AGENDA

IN RE:)
)
140 West 2nd) KETCHUM PLANNING AND ZONING COMMISSION
Design Review) FINDINGS OF FACT, CONCLUSIONS OF LAW, AND
Application File Number: P24-092) DECISION
)
)
Date: March 12, 2024)

PROJECT: 140 West 2nd
APPLICATION TYPE: Design Review
FILE NUMBER: P24-092
ASSOCIATED APPLICATIONS: Pre-Application Design Review P24-070
PROPERTY OWNER: 140 West 2nd Street LLC
REPRESENTATIVE: Michael Doty Associates, Architects
LOCATION: 140 W 2nd Street (Ketchum Townsite: Block 59: Amended Lot 1A)
ZONING: Mixed-Use Subdistrict of the Community Core (CC-2 Zone)
OVERLAY: None

AREA PLANS AND CALCULATIONS

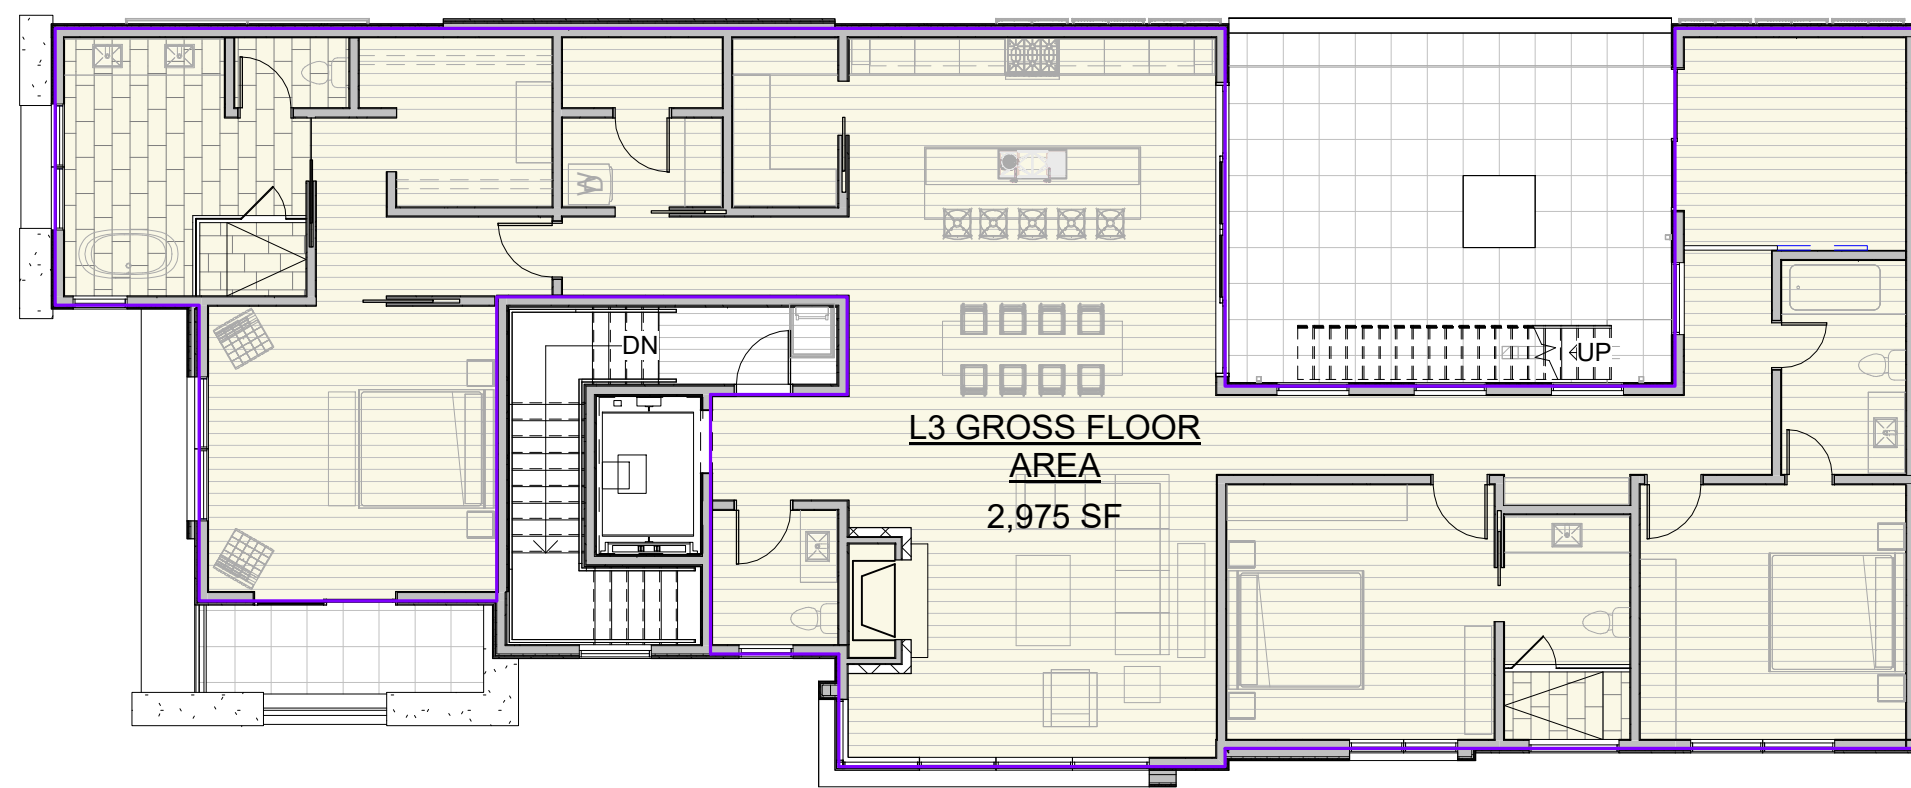
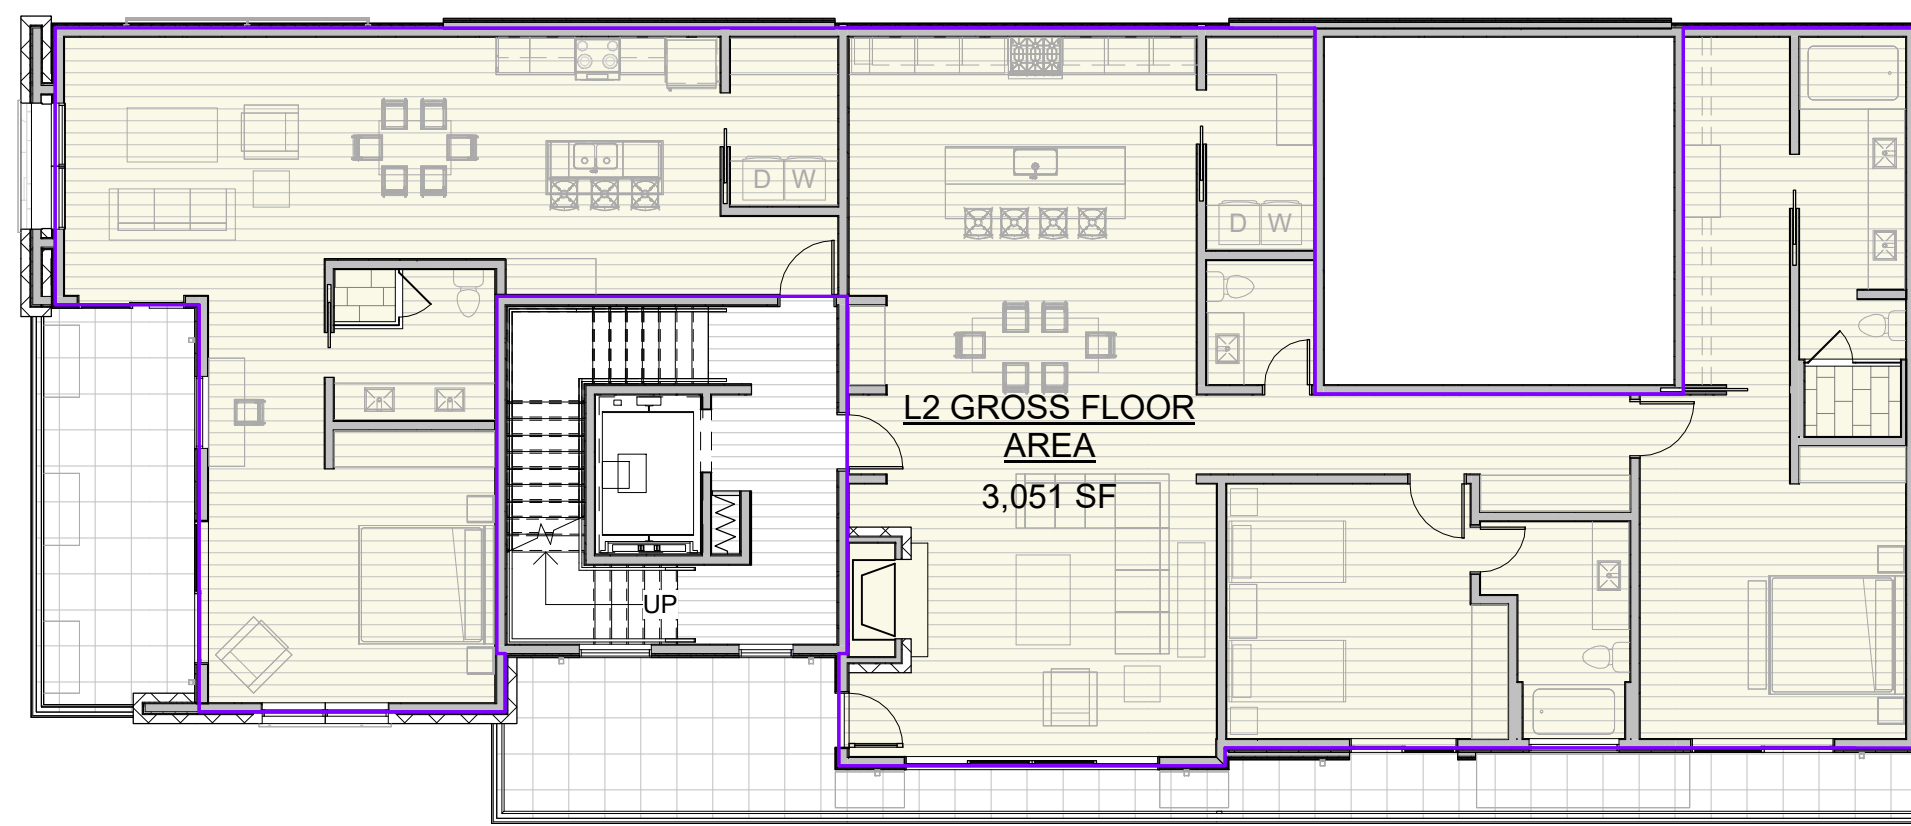
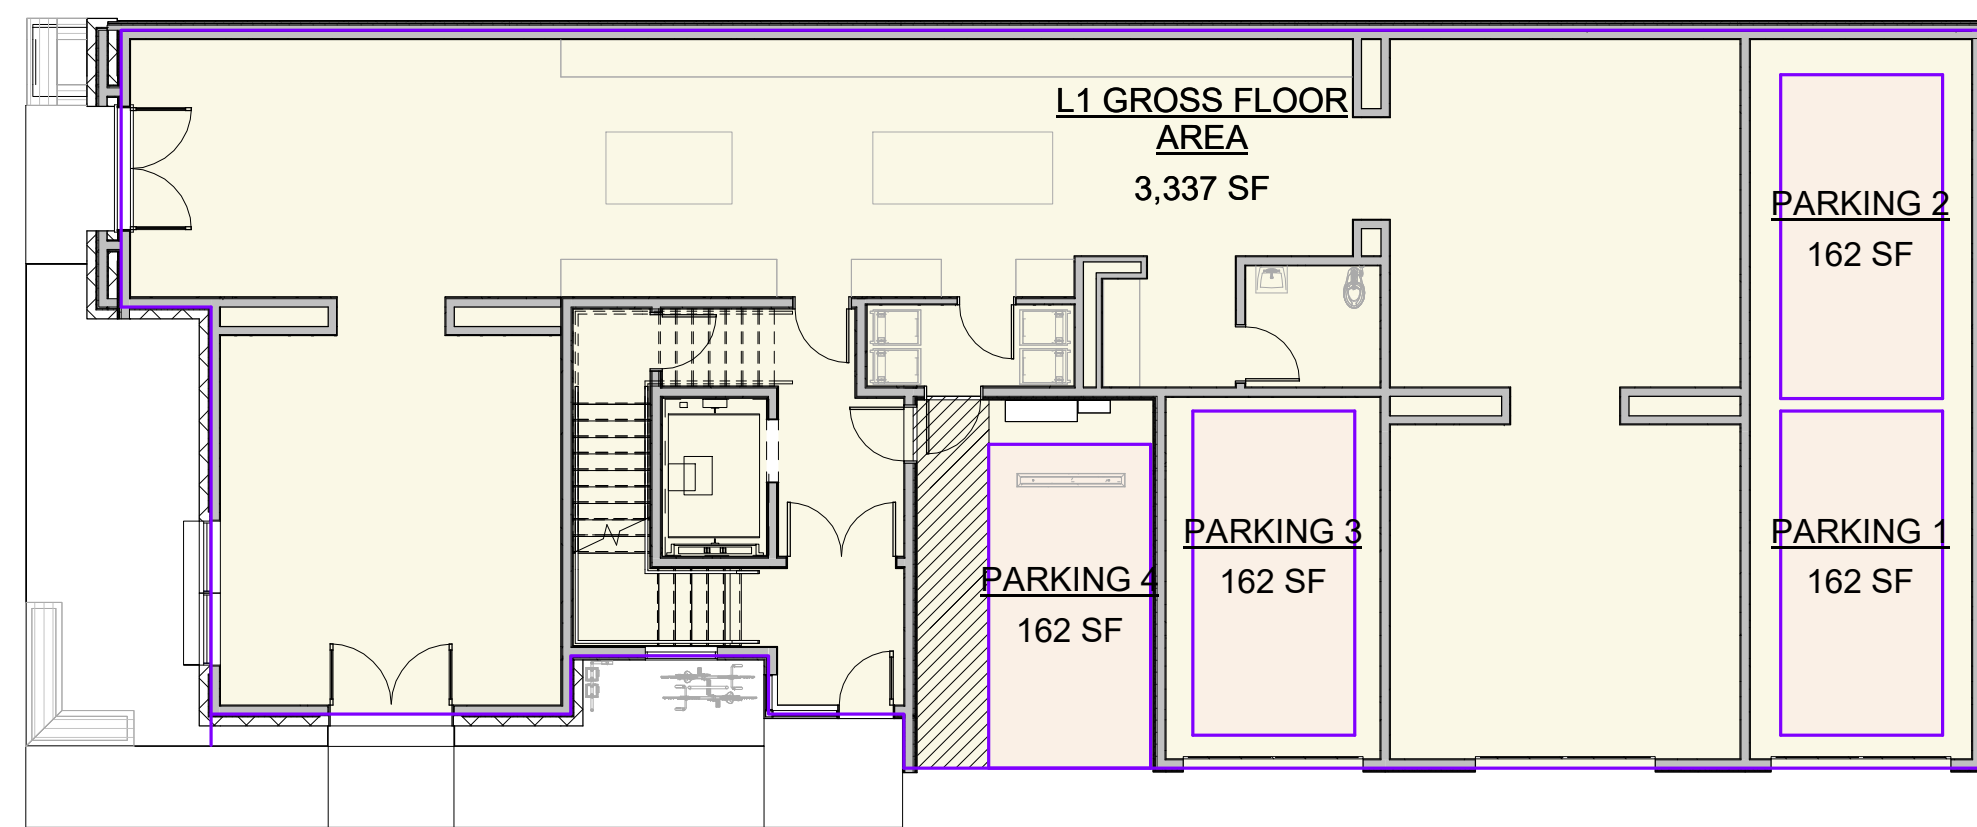
The FAR calculation is provided on Sheet A-010 of the project plans.

Project net and gross floor area calculations are provided on sheet A-010 of the project plans.
